**City of Albuquerque**

RE: PROJECT NO. 4369.90, DIAMOND SHAMROCK DECELERATION LANE, (MAP NO. K-10)

RE: DRAINAGE PLAN FOR DIAMOND SHAMROCK  
(K-10/D20B) ENGINEER'S STAMP DATED MAY 31, 1991

CITY OF ALBUQUERQUE  
PLANNING DEPARTMENT  
PLANNING DIVISIONAGENDA NUMBER: 09  
ENVIRONMENTAL PLANNING COMMISSION  
MAY 16, 1991  
Z-88-76-1

Job DIAMOND SHAM ROCK (CORE & BLOWMETER  
 Subject (AS-BUILT) POND CAPACITY  
 Client DIAMOND SHAM ROCK

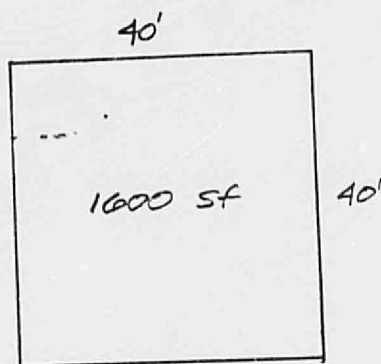
PLANIMETER READINGS  $\left. \begin{array}{l} 288 \\ 274 \\ 280 \end{array} \right\} \text{AVG} = 280.6667$

$$\text{CONSTANT} = \frac{1600 \text{ SF}}{280.6667} = 5.7007$$

CONTOUR	READING	AREA
B4	$\left. \begin{array}{l} 775 \\ 791 \end{array} \right\} \text{AVG} = 783$	4464 SF
B4.77 (OVERFLOW)	$\left. \begin{array}{l} 1132 \\ 1150 \end{array} \right\} \text{AVG} = 1141$	6505 SF
B3.40 (BOTTOM)		2434 SF

$$\left[ \frac{(2434 \text{ SF} + 4464 \text{ SF}) \times .6'}{2} \right] + \left[ \frac{(6505 \text{ SF} + 4464 \text{ SF}) \times .77'}{2} \right]$$

CAPACITY = 6292 CF ; RBR 5078 CF ✓
